**Brief report on the meeting to discuss division of the FIRST focal plane at  
ESTEC on 29 Oct. 98:**

**Matt Griffin  
30 October 1998**

## **Current arrangement**

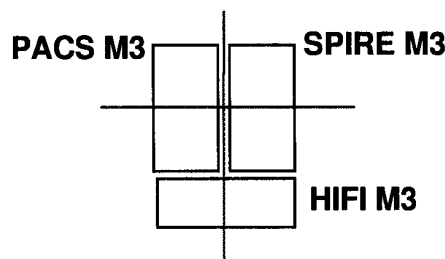
The alley between SPIRE and PACs is 80 mm wide and the centre of our M3 is around 90 mm from the telescope optical axis.

### Proposed solution for option 2:

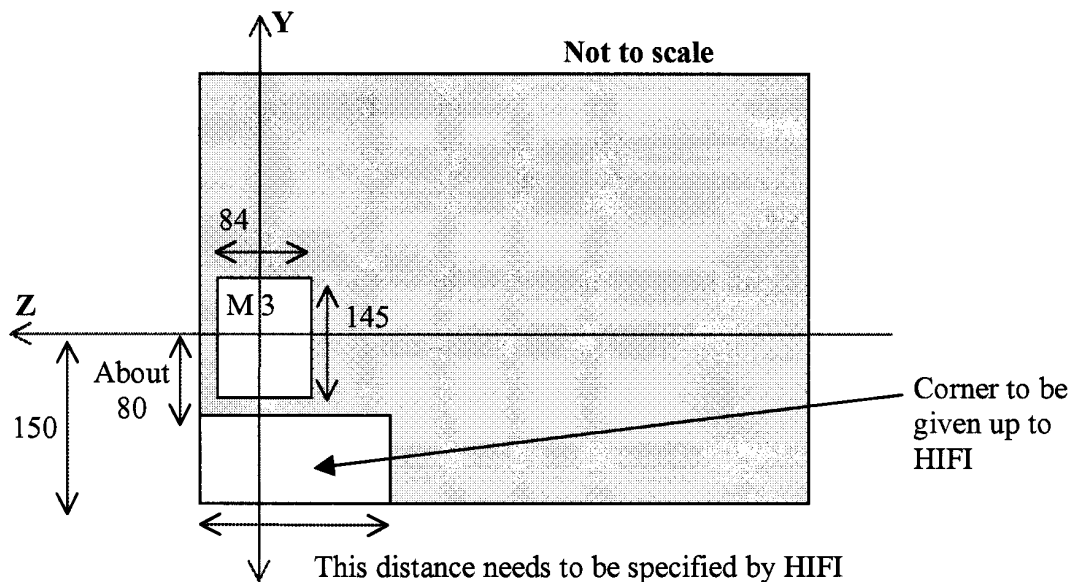
HIFI moves out of the alley. They turn their mirror through 90 degrees and occupy a region the outer part of the unvignetted field of view:

The gap between the SPIRE and PACS walls can be reduced to some small value compatible with ease of integration (say, 5 mm).

This would put the centre of our M3 at around 55 mm instead of 90 mm from the centre of the focal plane.

- They need to look at whether/how they can revise their chopping scheme with the mirror rotated through  $90^\circ$ .
- It will be a problem to fit their M3 inside the radius of the unvignetted fov (currently 120 mm)

1. PACS and SPIRE give them as much space as possible by moving our side walls closer to the centre of the focal plane

distance between centre of M3 and the wall = 150 mm  
 distance between edge of M3 and the wall = 78 mm

To help HIFI to move out, we need to reduce give up about around 80 mm, and PACS will do the same.

2. Even if PACS and HIFI can make this extra room available, that will probably not be quite enough, so the unvignetted field of view of the telescope needs to be expanded by around 10% by increasing the diameter of the hole in the primary. This would have
